## 7.2 Reactor Protection (Trip) System (RPS)—Instrumentation and Controls

The information in this section of the reference ABWR DCD, including all subsections, tables and figures, is incorporated by reference with the following departures and supplements.

**Figure 7.2-6 Division 1 Trip Logic**

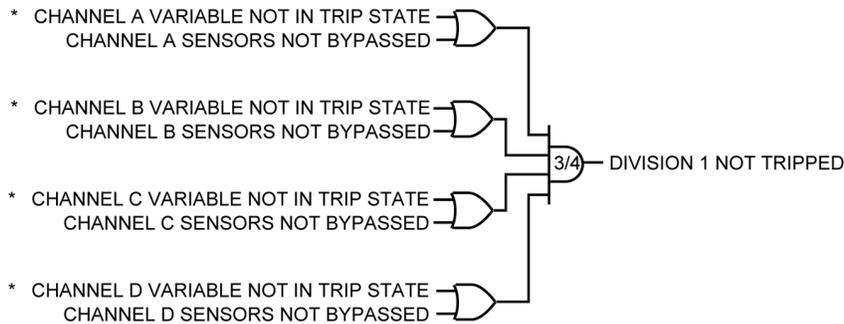
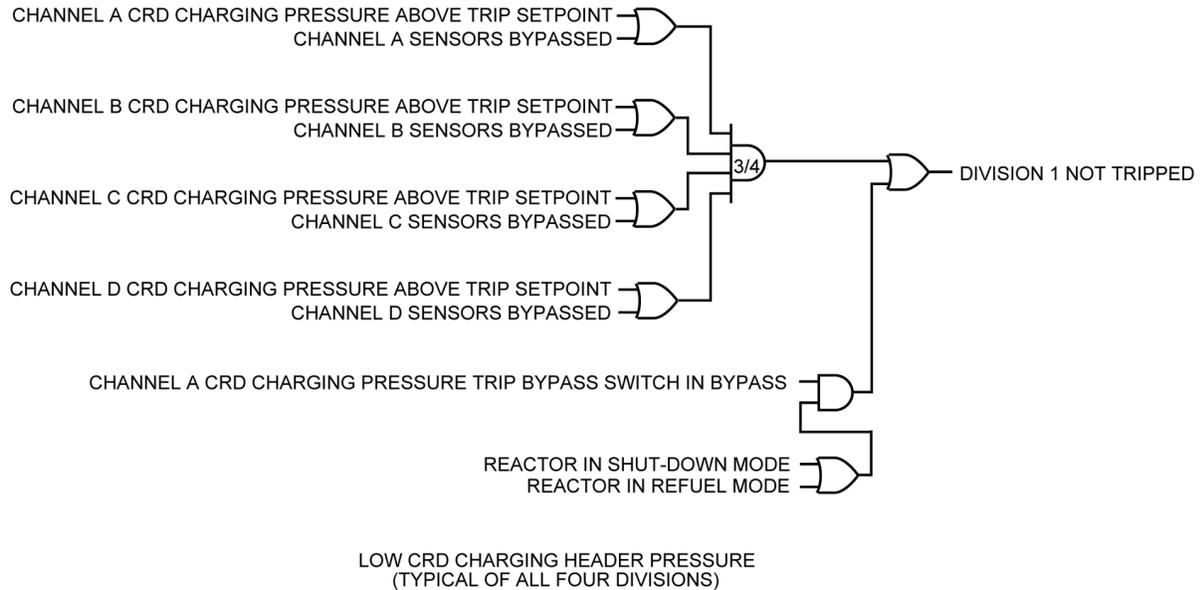
STD DEP T1 2.3-1 (Table 7.2-1, 7.2-2, Figures ~~7.2-3~~ 7.2.2, 7.2-6, 7.2-9, 7.2-10)

(4) ~~Process Radiation Monitoring (PRM) System (Figure 7.2-6)~~ Not Used~~(a) Main Steamline Radiation~~

#### ~~High Main Steamline Radiation Trip (Figure 7.2-6)~~

~~A high main steamline radiation trip will occur in each division of trip logic when a main steamline radiation trip condition exists in any two or more unbypassed sensor channels. There are no operating bypasses associated with this trip function.~~
